Subject: Approval, First Time System Variance Request, Versteeg property, Church Hill Road, Augusta

**FIRST TIME SYSTEM VARIANCE REQUEST**

# SURFACE WASTEWATER DISPOSAL SYSTEM APPLICATION

## SUBSURFACE WASTEWATER DISPOSAL PLAN

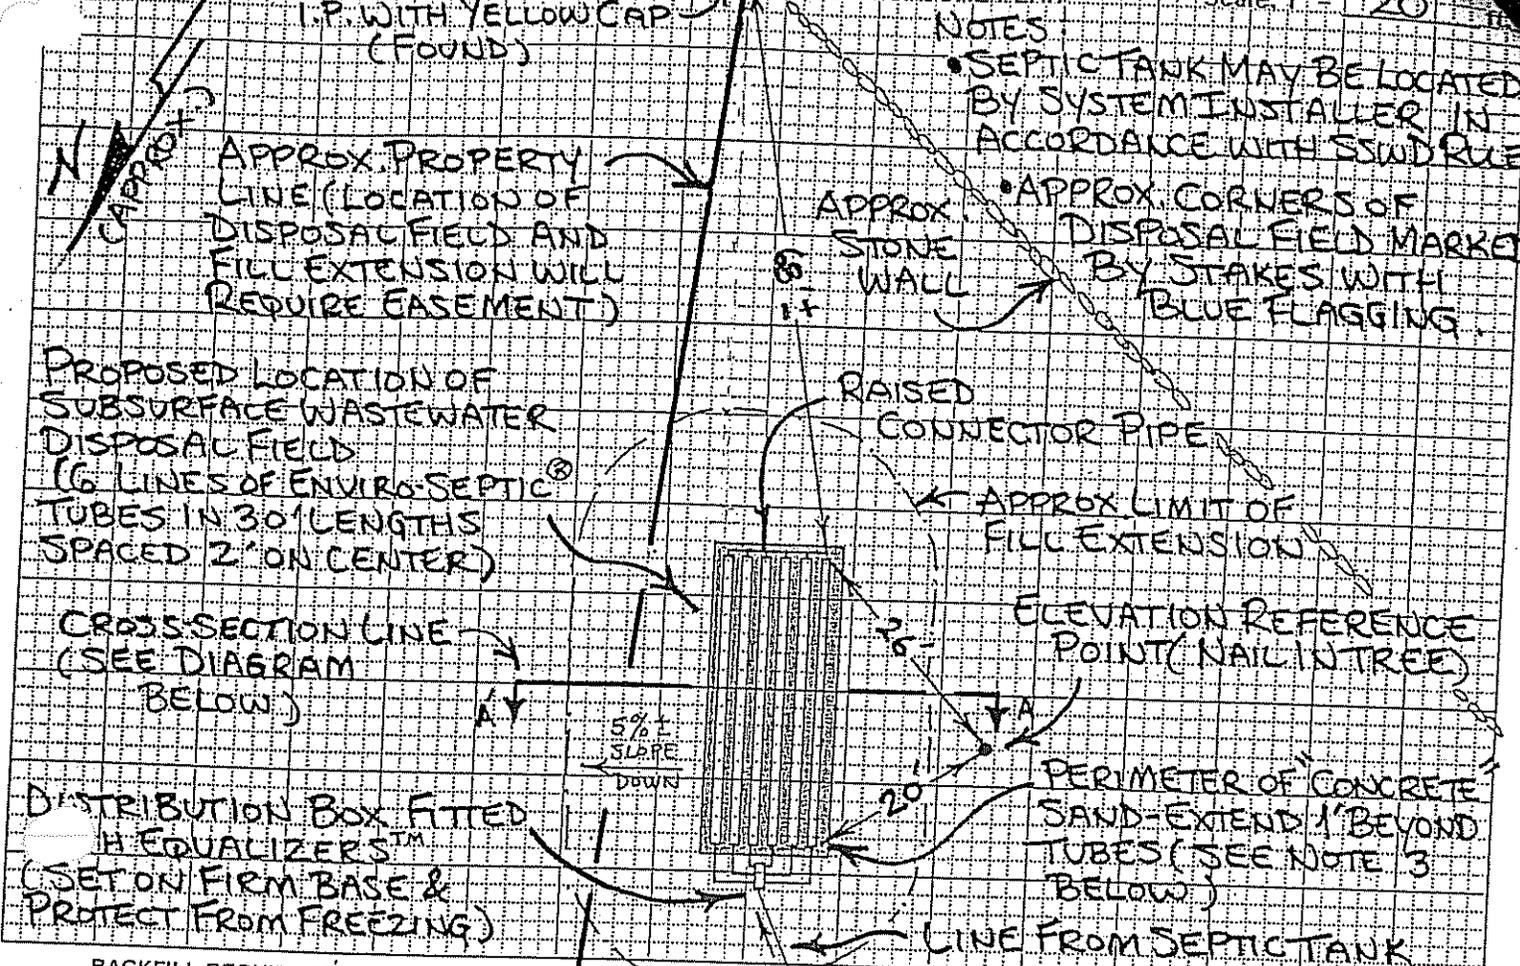
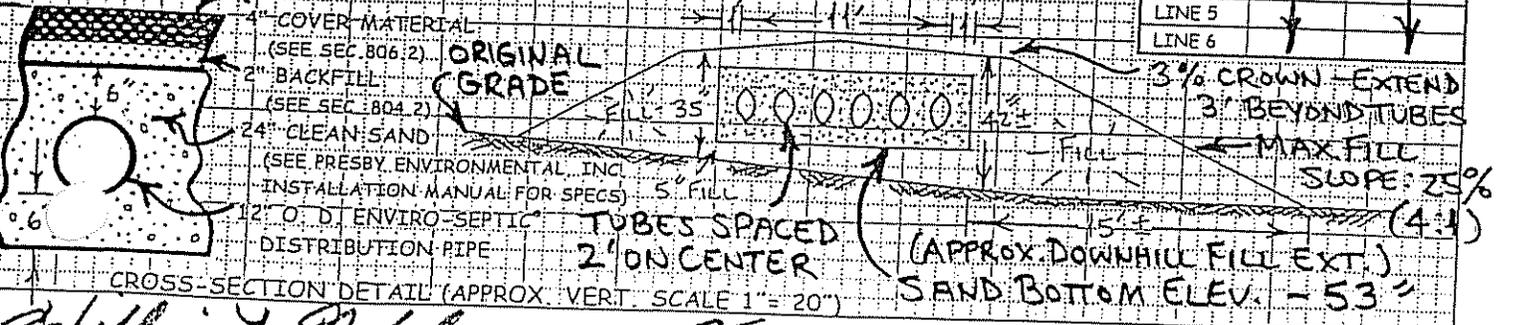
The complaint was that the newly installed septic system was too close to the well which is located under the front porch of Mr. Merrick's dwelling. After we both measured the distance to the well and the septic leachfield, the distance was 89 feet, and from the footprint to the IP with yellow cap located at the end of Mr. Merrick's rock wall as shown on the HHE-200 form was 57 feet.

Together, we have come to the conclusion that the septic system was installed in the wrong location, therefore shall be moved in accordance with the HHE-200 form designed by Mr. William Noble on May 3, 2003 and relocated 100 feet from Mr. Merrick's well.

After measuring the system to the Merricks well and several other points on the property we have found that this system was actually pivoted on one end, which resulted in a well setback of less than 100 feet.

At this time we must request that you notify us of your intentions to correct this situation.
